ADA Curb Ramp New Construction Inspection Form (Parallel)

NW Main

23885.56

NW Lenox

PARALLEL RAMP (PL)

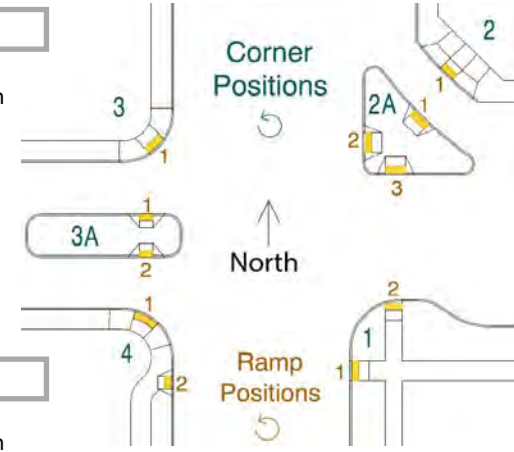
7.9 $\leq *$ ☐ $> *$ ☒

15.4 $\leq 8.3\%$ ☐ $> 8.3\%$ ☒

6.4 $\leq 2.0\%$ ☐ $> 2.0\%$ ☒

3.3 $\leq 2.0\%$ ☐ $> 2.0\%$ ☒

DWS IITD Fails RR 1
